ROSS & PARTNERS

29 NEW END

RESPONSE TO BASEMENT IMPACT ASSESSMENT ADDENDUM AUDIT

This brief technical note has been prepared to address audit queries raised by Campbell Reith in Revision D1 of their audit document entitled “29 New End, London NW3 1JD – Basement Impact Assessment Addendum Audit” dated April 2018 (Reference [1]). The present note is limited to issues insofar as they relate to GCG’s modelling reported in Revision 1 of GCG’s document entitled “29 New End: Assessment of the effects of redevelopment on neighbouring buildings” dated October 2017 (Reference [2]).

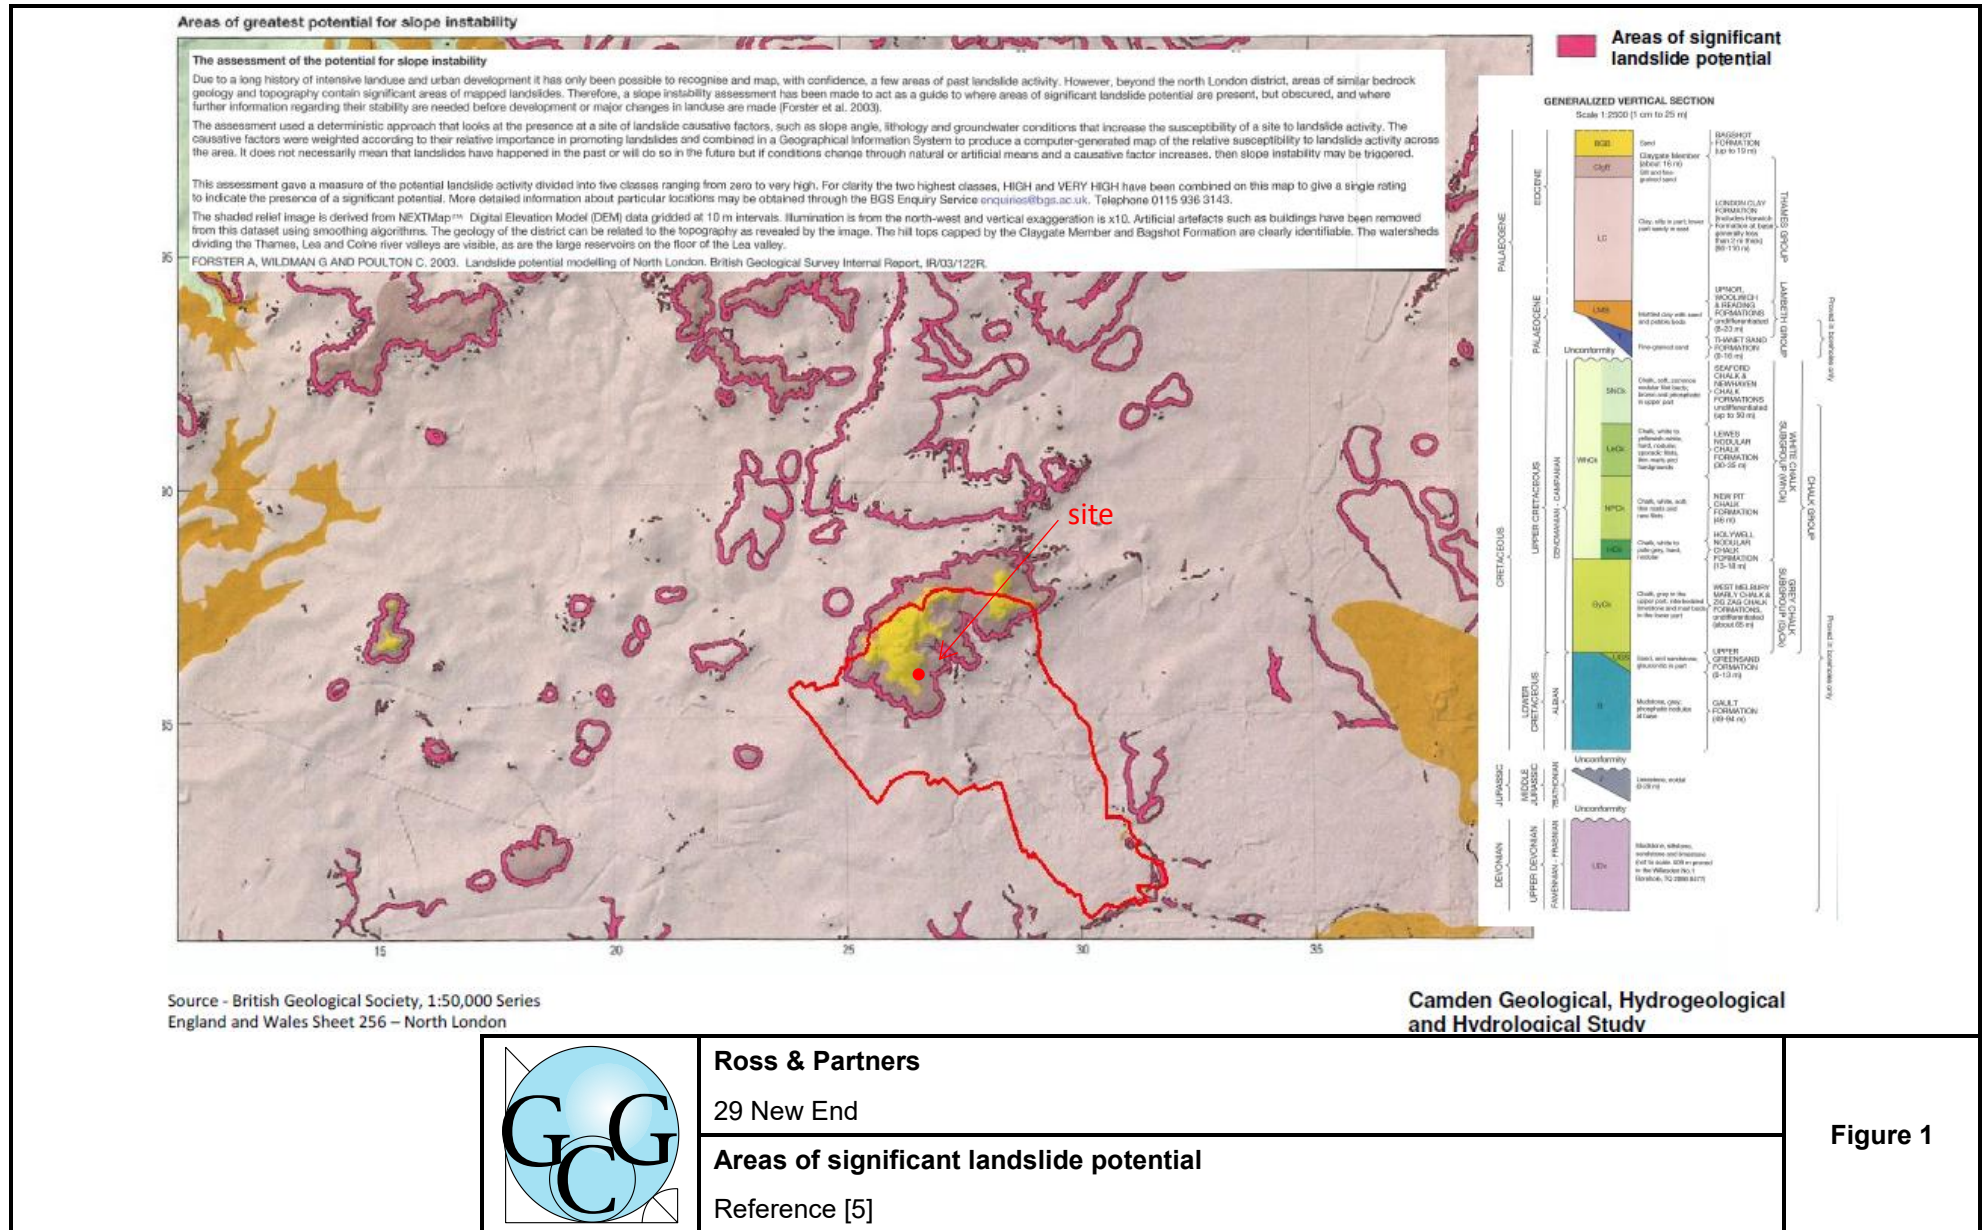
4. The Hampstead area and the surroundings are considered to be vulnerable to slope instability due to the ground conditions and the sloping gradient of the ground. Potential land instability has generally been associated to slopes of 8° or greater both in the London Clay and in the Claygate Member (Reference [3] and Reference [4]) although the mechanisms that could drive the potential instability are different in the two types of soils.

Figure 1 shows the areas that are prone to slope stability issues as mapped by the British Geological Survey (BGS) (Reference [5]). The BGS mapping is based on factors such as geology and groundwater conditions, in addition to the slope angle.

The site specific conditions at 29 New End do not suggest that issues with general land stability exist. The slope of the ground at the site is about 7° and, given the hydrological conditions, it is unlikely that pore water pressure increase in the clayey units of the Claygate Member could occur leading to instability of the ground.

The proposed basement construction is not likely to adversely change the existing conditions. Retaining walls are being used to retain the ground behind the new basement. The walls will be propped during construction and in the long term and we understand that they have been designed for appropriate earth pressures. The 3D FE analyses simulating the proposed re-development as reported in Reference [2] confirmed that no issue of ground instability exist.

Ross & Partners 29 New End	Figure 2
	SPT test data with assumed variation in Bagshot sand layers

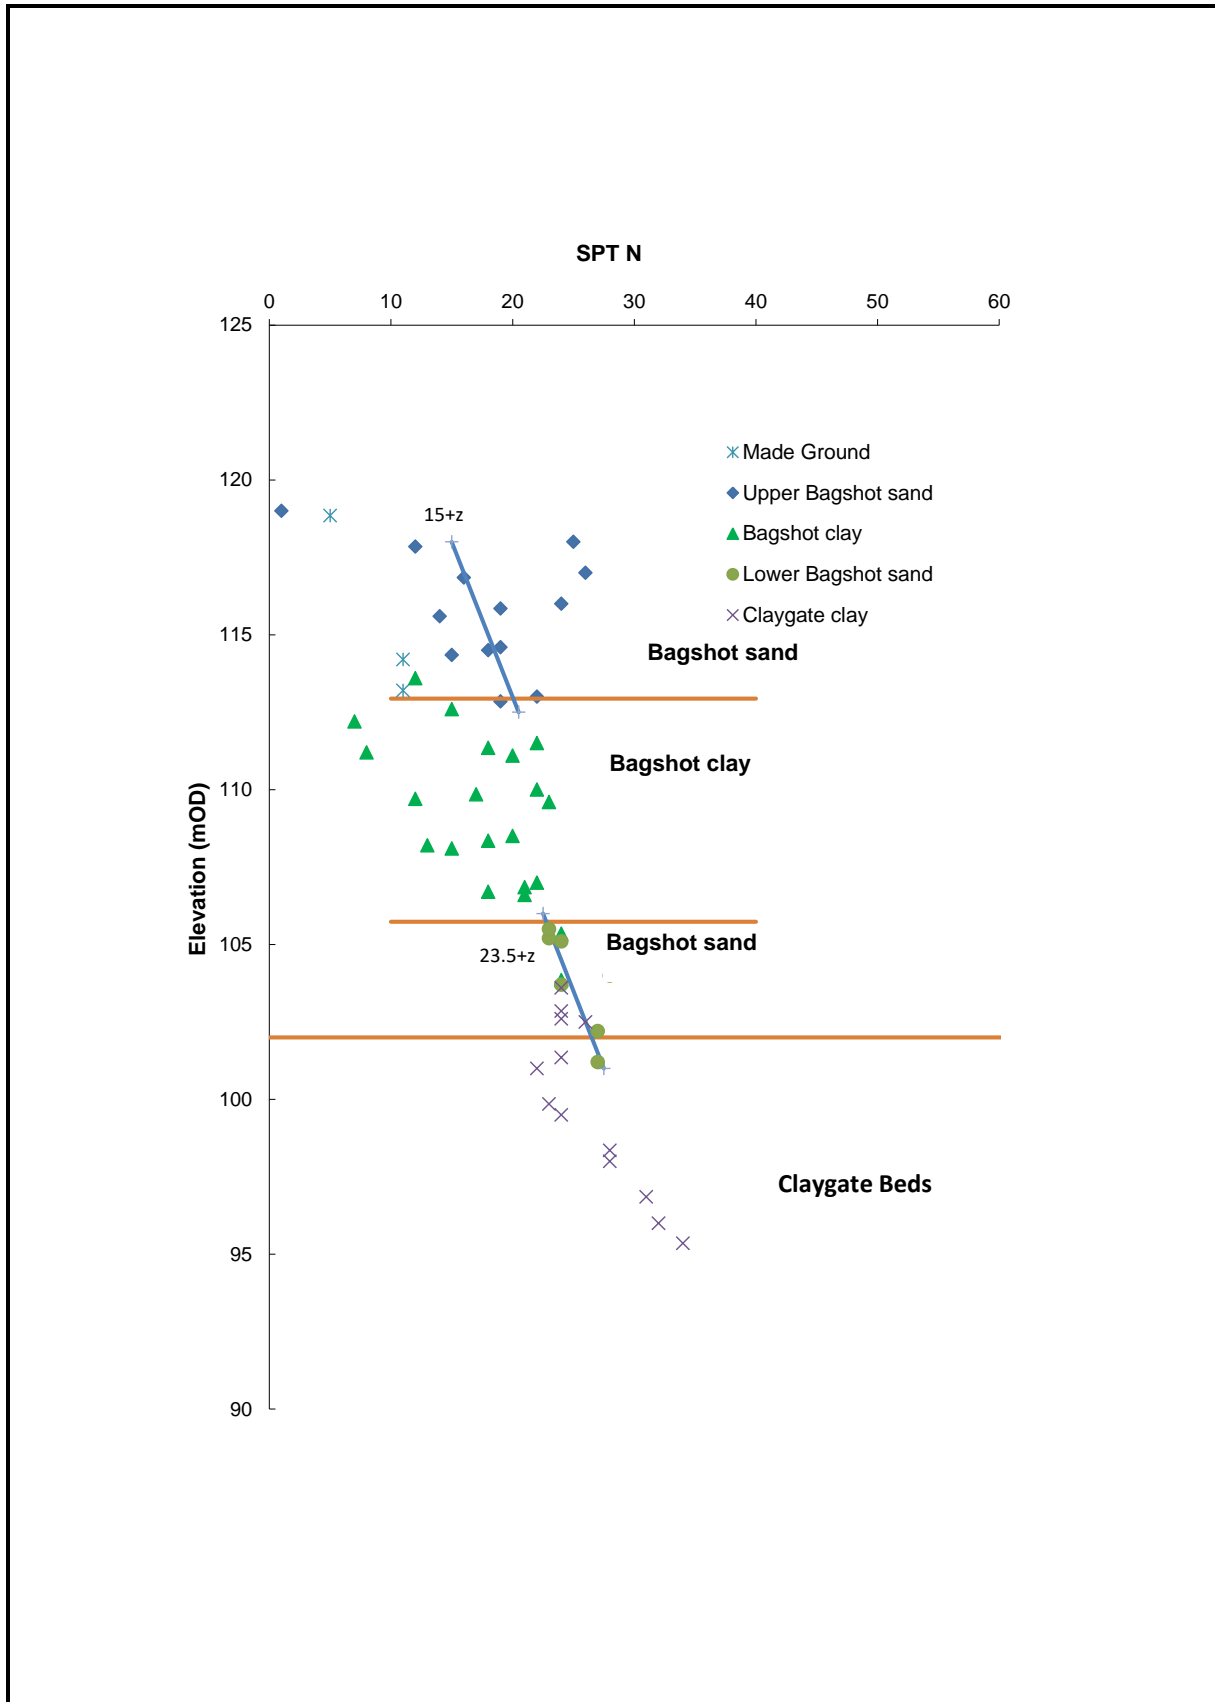
6. As outlined in Section 3.2 of Reference [2] a constant Young's modulus of 10MPa was assumed for the thin layer of Made Ground. This is considered to be reasonably conservative and is consistent with the value adopted in Reference [6].

The drained stiffness for the two Bagshot sand layers can be compared to the SPT data (see Figure 2) using empirical relationships. In this case the following relationship was used:

$$E' = 2 \cdot N_{SPT}$$

The variation of N_{SPT} with depth for the two layers of Bagshot sand consistent with the assumed drained stiffness is indicated in Figure 2.
